SUBJECT: Forwards response to requests for addl info re special
 lifting devices used for control of heavy loads
 (ref NUREG-0612).

Subject: Control of Heavy Loads
R. E. Ginna Nuclear Power Plant
Docket No. 50-244

The following pages list additional information regarding the Special Lifting Devices at R. E. Ginna Nuclear Power Plant.

Figure 1 - Reactor Coolant Pump Motor Lift Sling

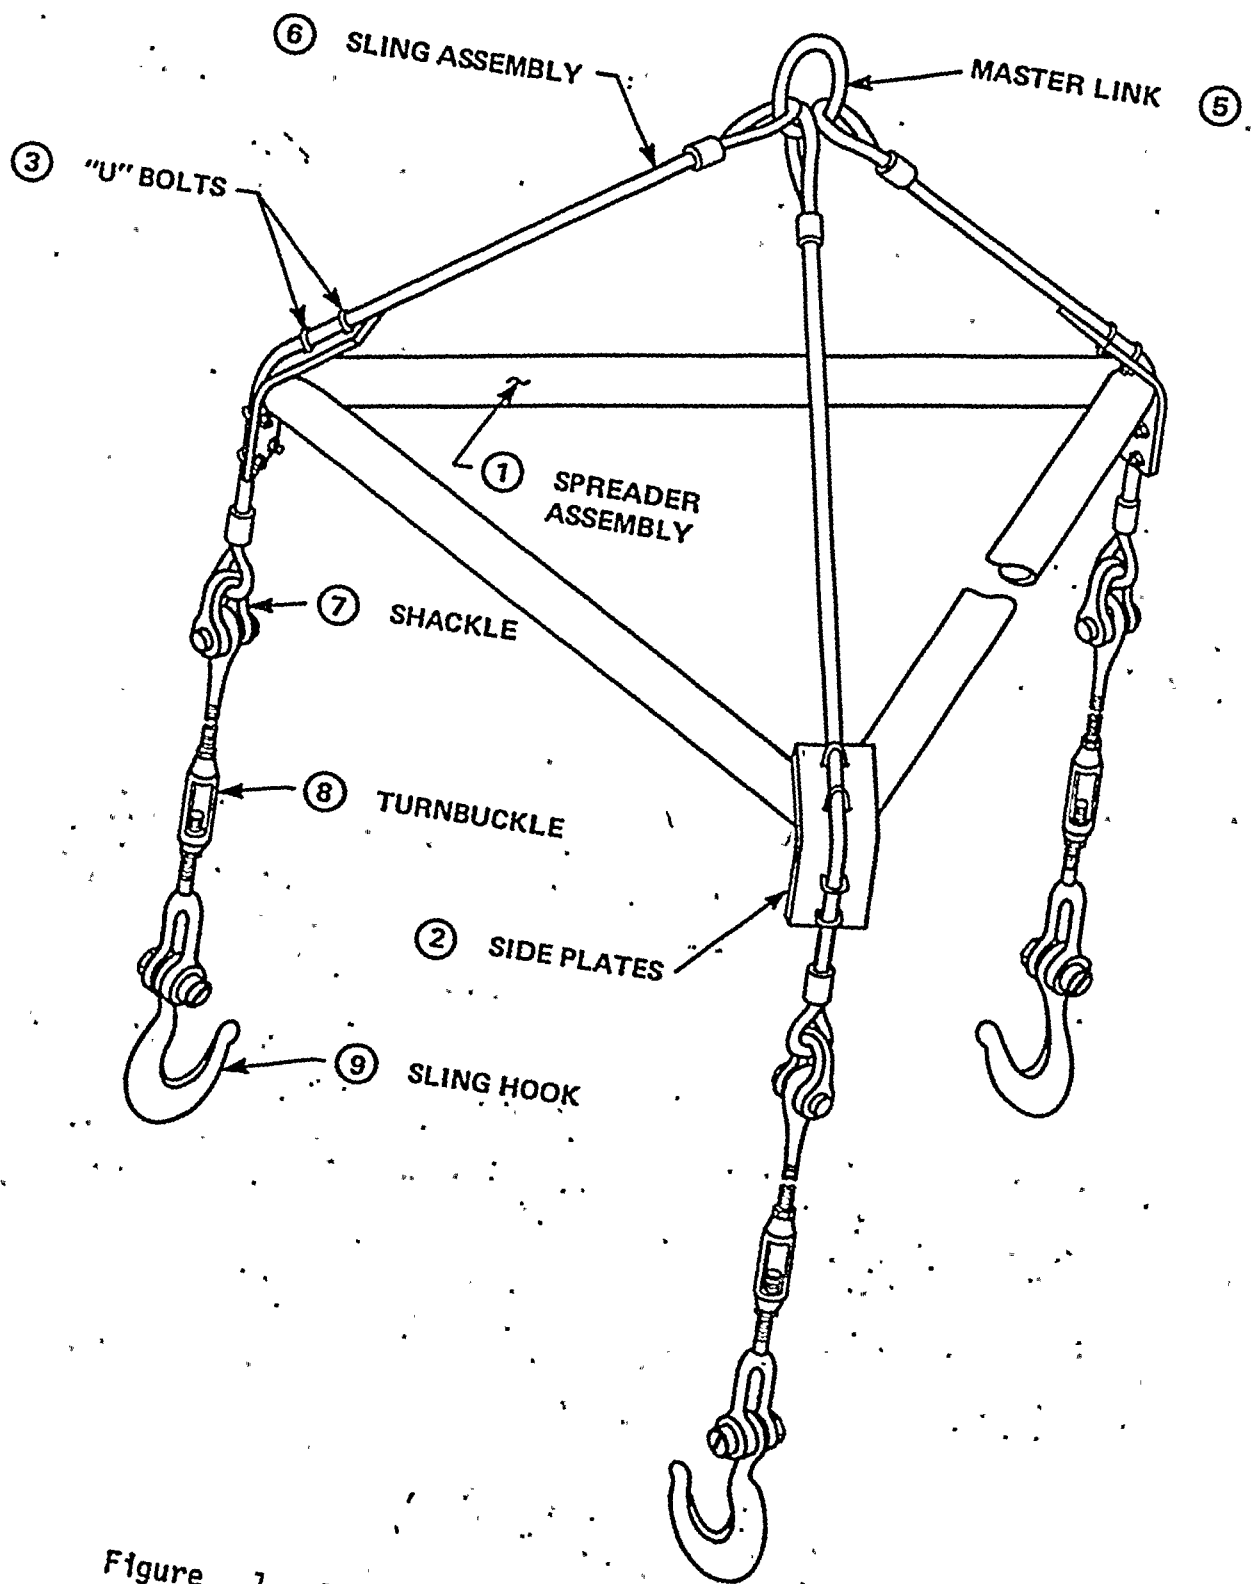
It can be seen from the sketch that this device is basically a spreader bar and is a very simple lifting assembly. The stress design margins are within ANSI N14.6 criteria as shown in the stress results. The welds on the rig underwent non-destructive examination during fabrication as listed in the information provided and again during our Spring 1983 outage under our continued compliance program.

This lifting sling is used in containment where it is not feasible to be load tested due to physical space and load requirements. It cannot be removed from containment in one piece; unless the equipment hatch fixture is removed. Load testing outside containment would require decontamination.

Based on the evaluation results; the simplicity of the device; the fact that the device has lifted 100% of its rated load; and the existence of a continued compliance inspection program RG&E believes that a load test is both unnecessary and impractical.

Figure 2 - Reactor Vessel Head Lift Rig

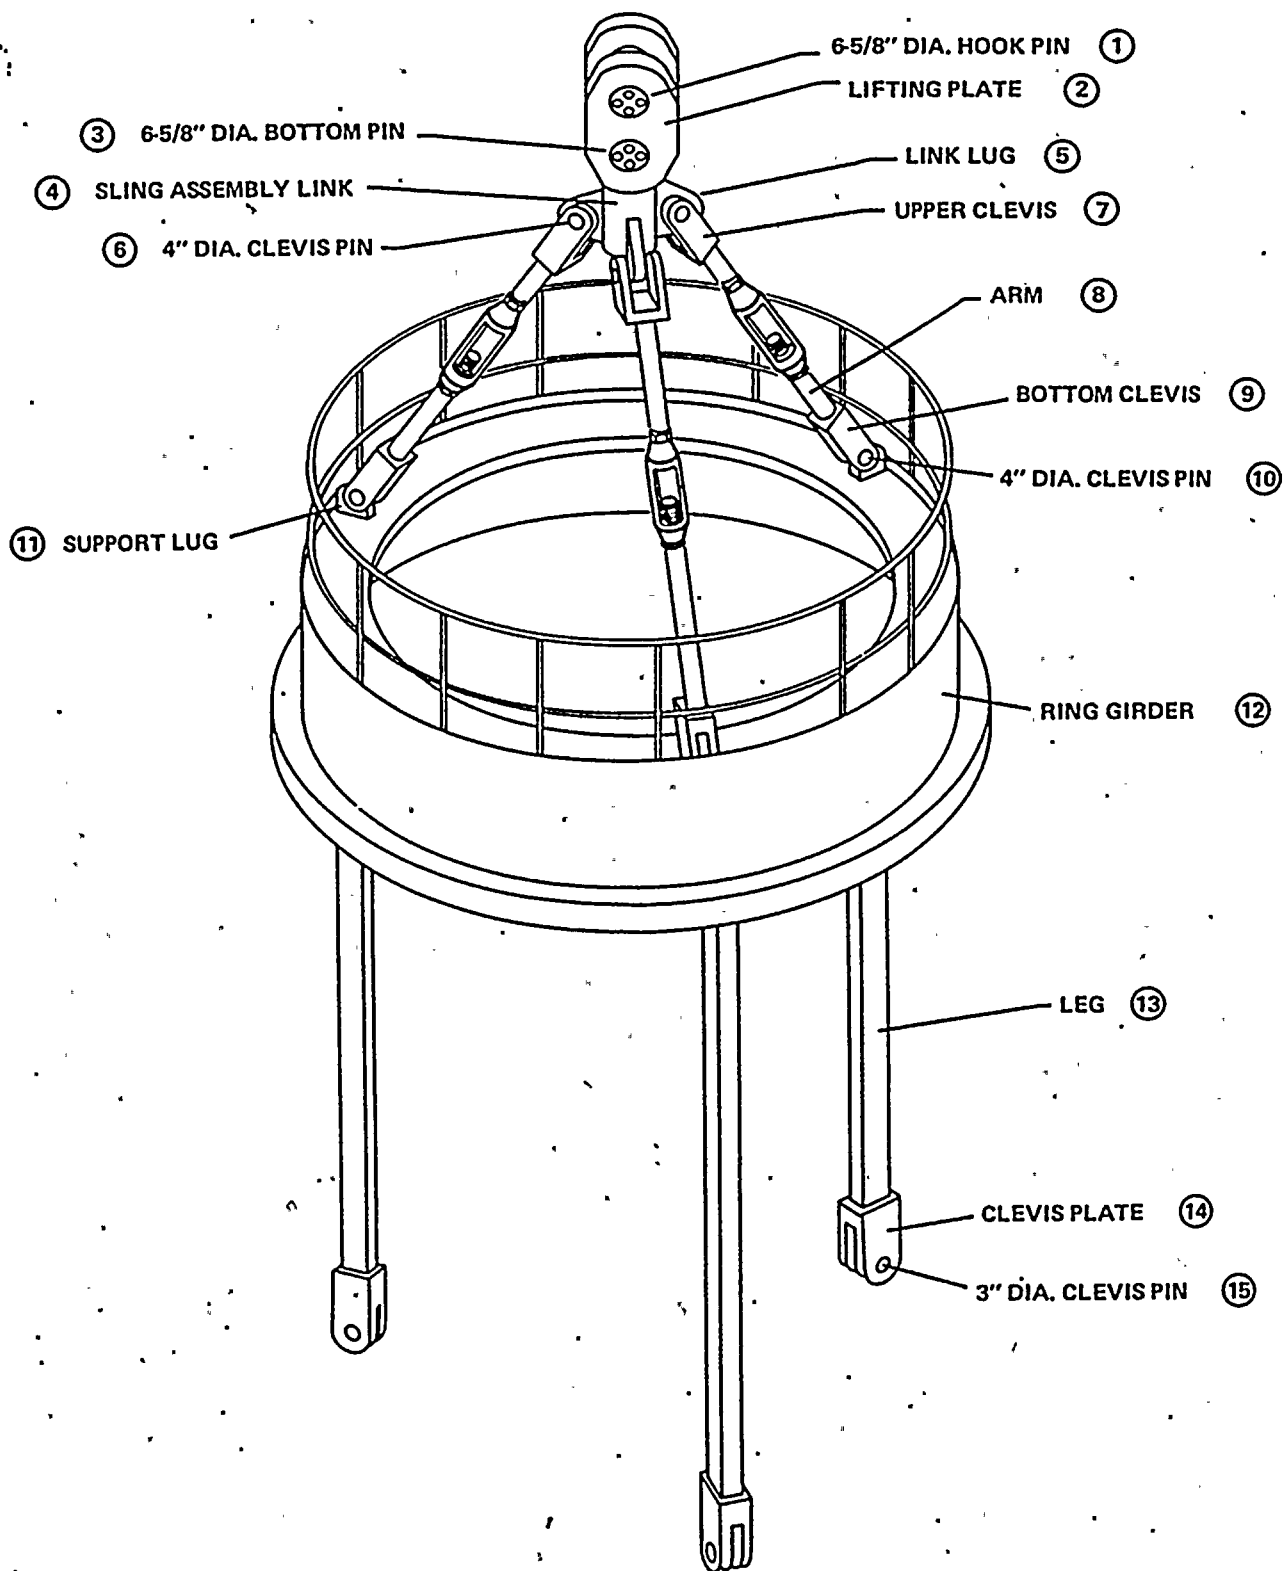
- 3) Reactor Vessel Head Lift Rig - Attached to this report is a sketch of this lifting device (Figure 2); a list of material properties (Table 5); weld examinations done during fabrication (Table 6); and the summary of stress results (Table 7).

As shown and listed in the attachments, there are three (3) sets of critical welds which were examined during construction and which are encompassed in the existing continued compliance inspection program. During our Spring 1983 outage, the link lug to sling assembly link welds were examined with the remaining weld inspections scheduled for the Spring 1984 outage.

It can be seen from Table 7 that the stress levels for lift rig components are well within ANSI N14.6 Guidelines.

Because of the size and configuration of the lifting rig, final fabrication was completed inside containment. It is physically impossible to get it outside of containment in one piece. It is also, because of limited space, and the load requirements, impractical to perform a rated load test in excess of 100%. The rig has been tested to 100%.

Based on the evaluation results which show substantial margins of safety in the lifting device design, the existence of a continued compliance inspection program, and the devices proven capability to lift 100% of its design load RG&E believes that this lifting rig adequately satisfies the guidelines of ANSI N14.6. A load test is neither warranted nor practical.
